Project: Fillmore High School Modernization

Project Number: WGD 20624 DSA# 03-121233

Addendum 03 – Mechanical Unit Replacement

Date: September 8, 2023

MB1-1.2 – Library Mechanical Demolition Roof Plan

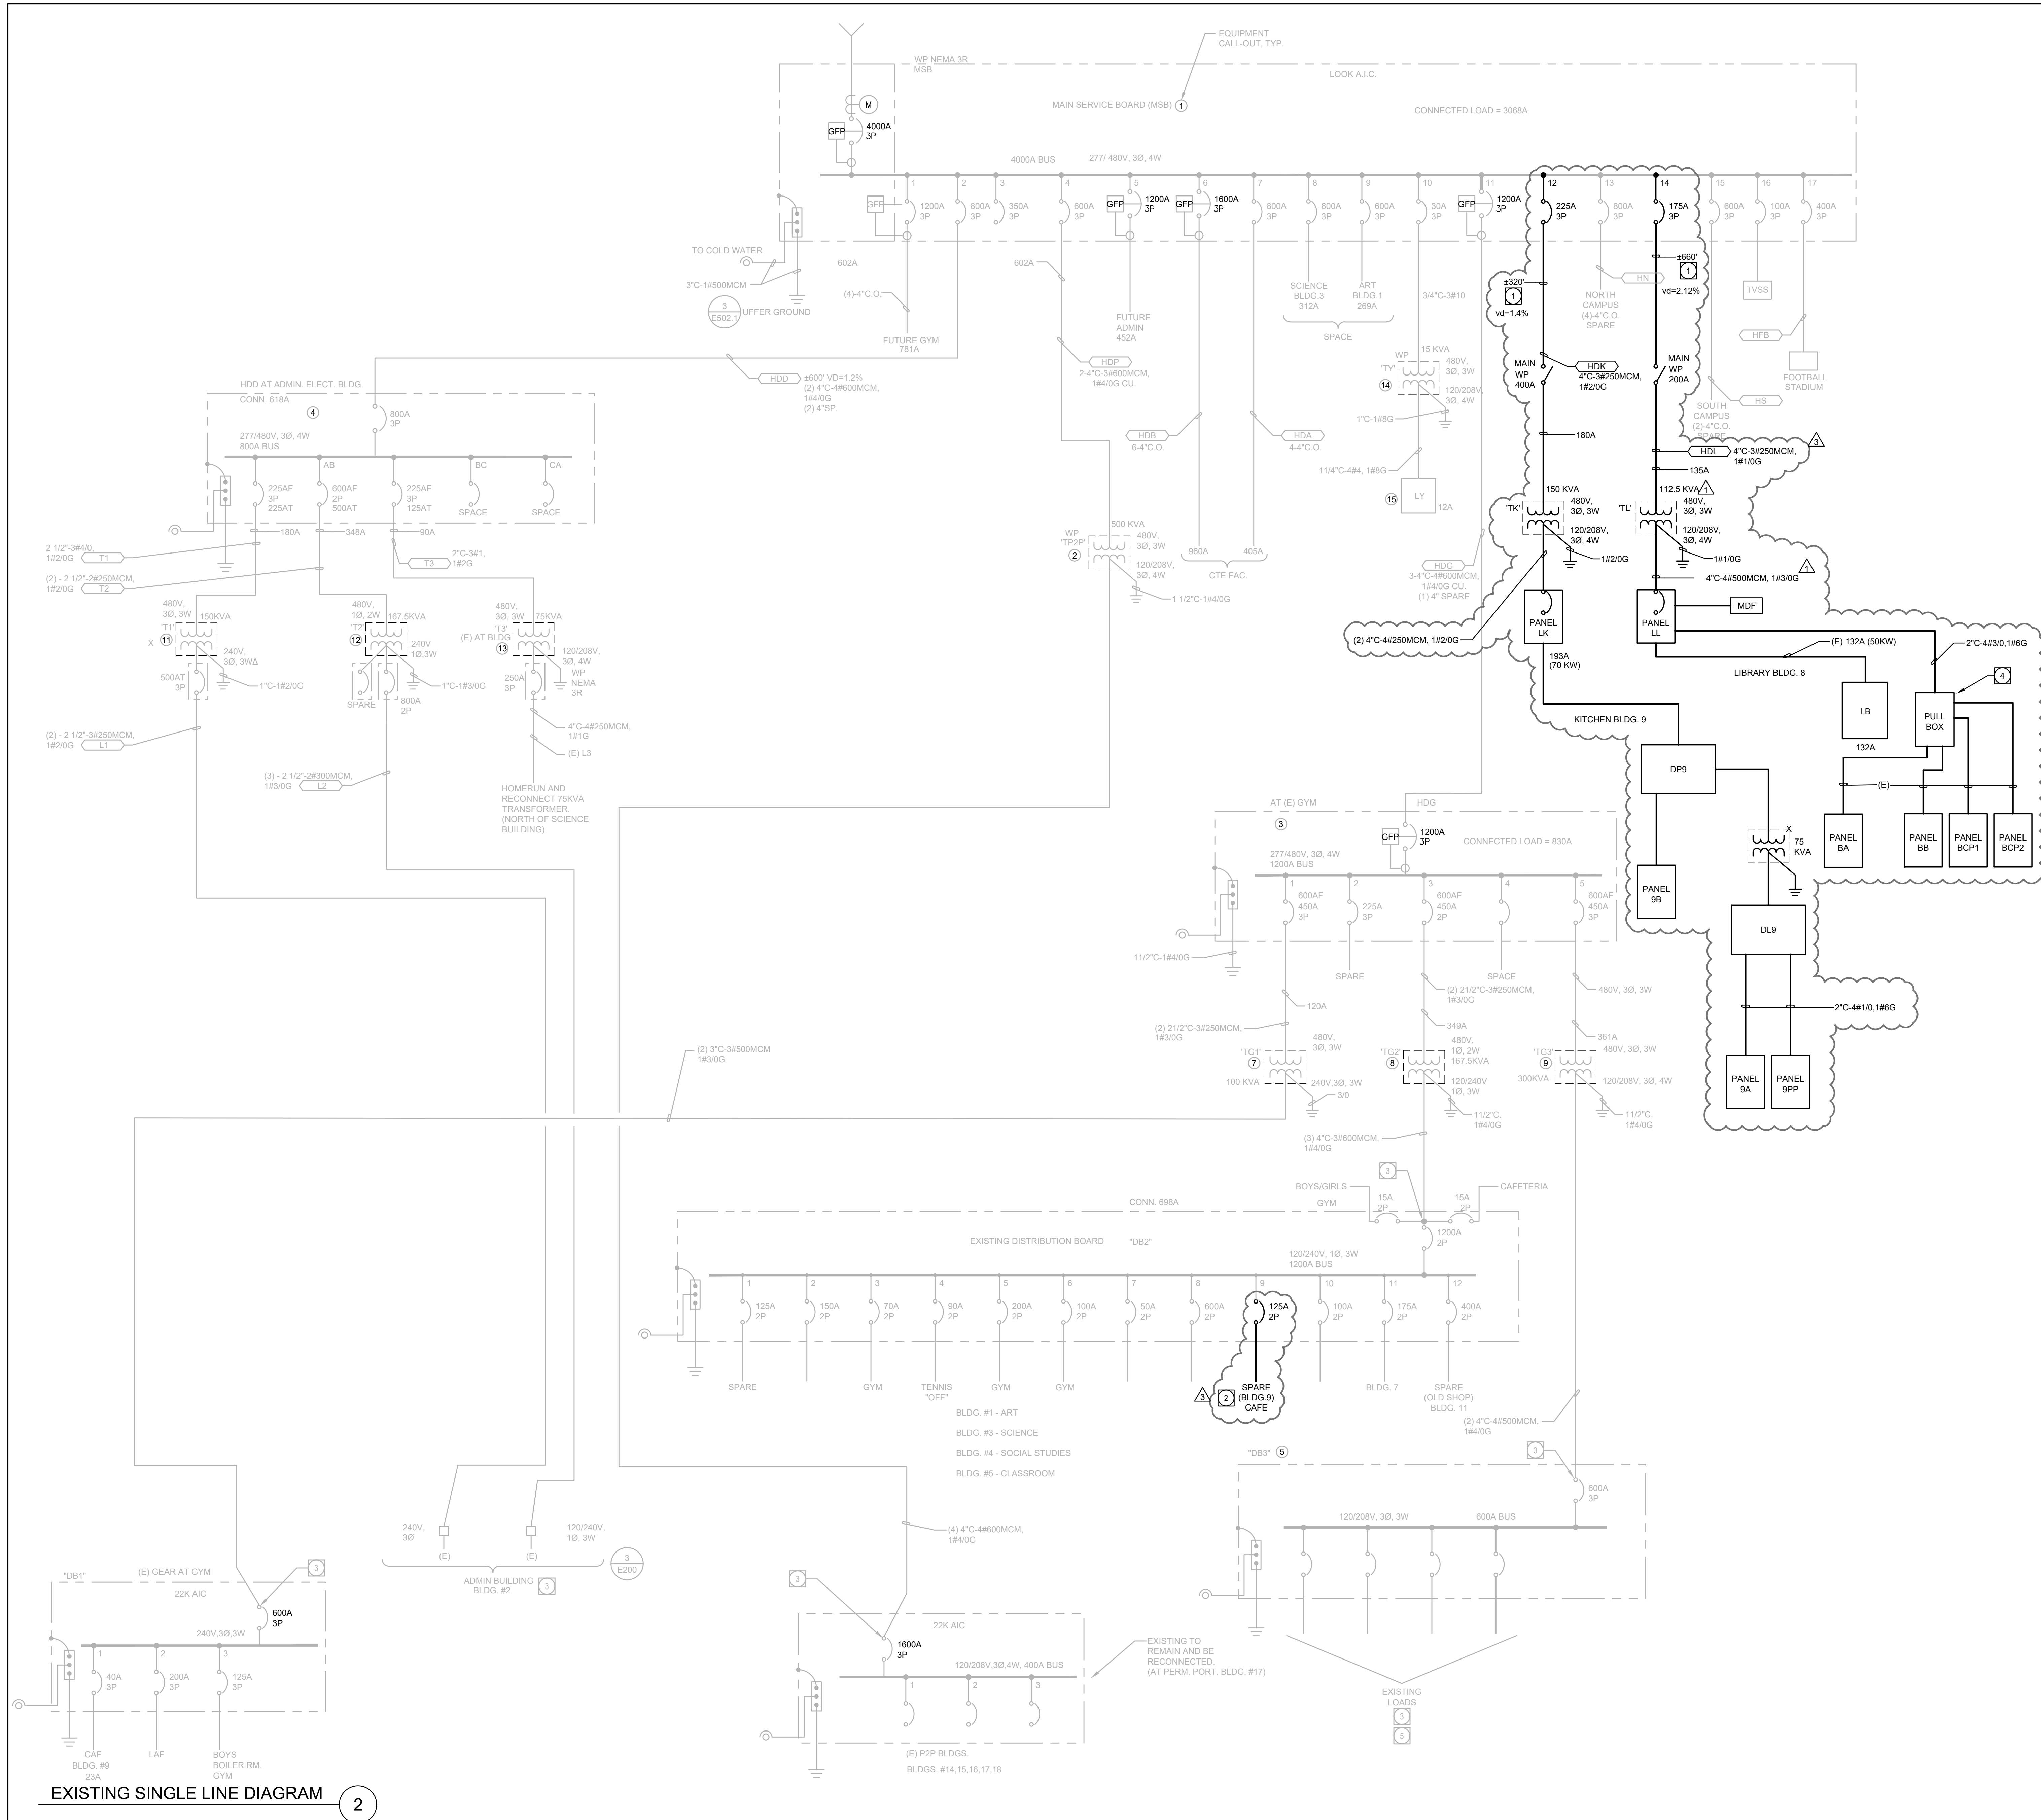
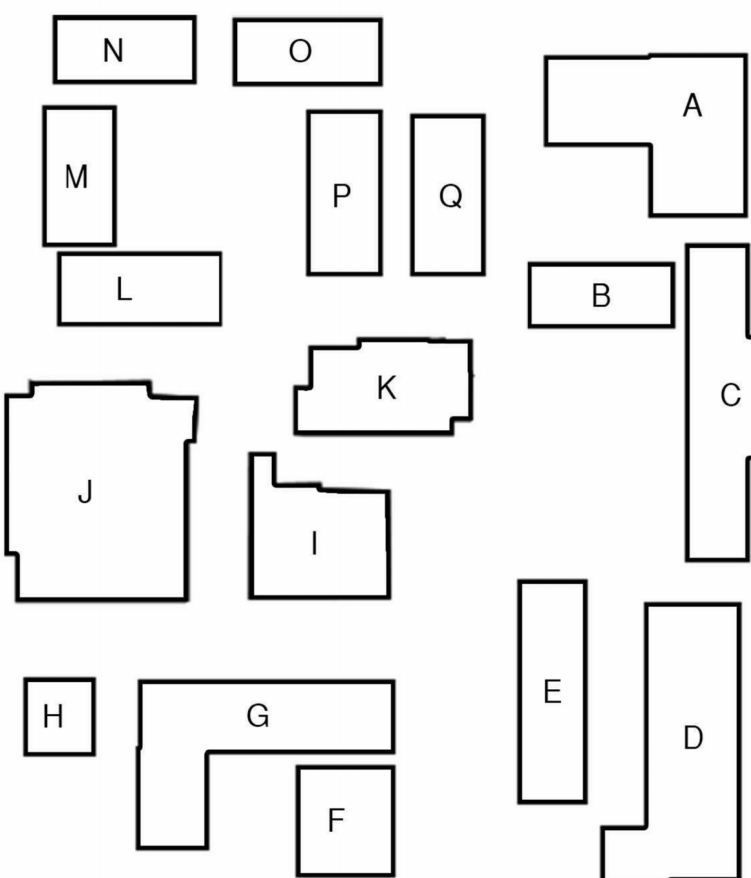
- a. Revised Plan Notes 1 and 4.
